**SUBDIVISION,
PLANNED UNIT DEVELOPMENT, &
ZONING AMENDMENT STAFF REPORT****Date: January 5, 2023**

<u>NAME</u>	Swintindustrial Mobile AL, LLC (Jefferson Bennett, Agent)
<u>SUBDIVISION NAME</u>	Swintindustrial Subdivision
<u>LOCATION</u>	West side of Hillcrest Road, 0.2± mile South of the West terminus of Nevius Road
<u>CITY COUNCIL DISTRICT</u>	District 6
<u>PRESENT ZONING</u>	LB-2, Limited-Neighborhood Business District
<u>PROPOSED ZONING</u>	B-5, Office-Distribution District
<u>AREA OF PROPERTY</u>	1 Lot / 80.3± Acres
<u>CONTEMPLATED USE</u>	<p>Subdivision approval to create one (1) legal lot of record from one (1) metes-and-bounds parcel; Planned Unit Development Approval to allow multiple buildings on a single building site; and Rezoning from LB-2, Limited Neighborhood Business District to B-5, Office-Distribution District.</p> <p>It should be noted, however, that any use permitted in the proposed district would be allowed at this location if the zoning is changed. Furthermore, the Planning Commission may consider zoning classifications other than that sought by the applicant for this property.</p>

The applicant is requesting Subdivision approval to create one (1) legal lot

SITE PLAN

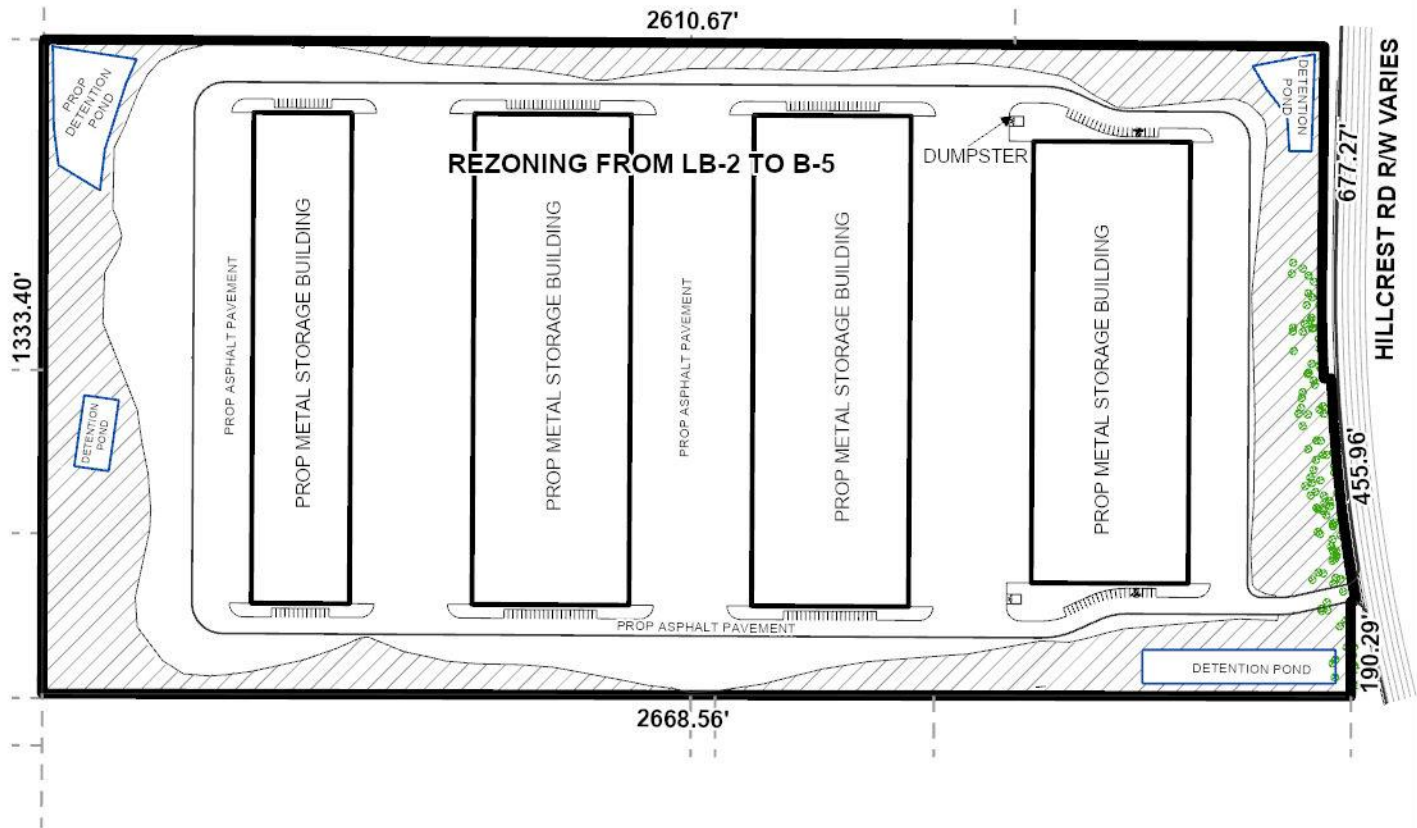
The proposed site plan depicts a total of four (4) buildings totaling 942,400± square feet. No information is provided regarding the amount of office space to be located on the site, nor is the amount of warehouse employees provided, making it difficult for staff to determine the number of parking spaces required. The site plan does depict 148 parking spaces, with ample room to provide additional parking, should it be needed. If approved, the site plan should be revised to address the amount of office space and warehouse employees so that staff can confirm sufficient parking is provided.

The site plan depicts two (2) dumpsters, with enclosures. If approved, the site plan should be revised to state that the dumpsters will have compliant enclosures and connections to sanitary sewer.

The 25-foot front minimum building setback is not shown along Hillcrest Road or Schimpfs Lane Extension on the PUD site plan. If approved, the 25-foot setback should be shown along all street frontages on the site plan.

City, a compliant buffer must be provided. If approved, the site plan should be revised to depict a compliant residential buffer.

The applicant depicts several existing trees on the site will be preserved. If approved, all existing trees to be preserved should be retained on the site plan with their size and species provided. The proposed development will be required to fully comply with tree planting and landscape area requirements, with tree planting to be coordinated with staff. The site plan submitted indicates full compliance with landscape area requirements will be provided.
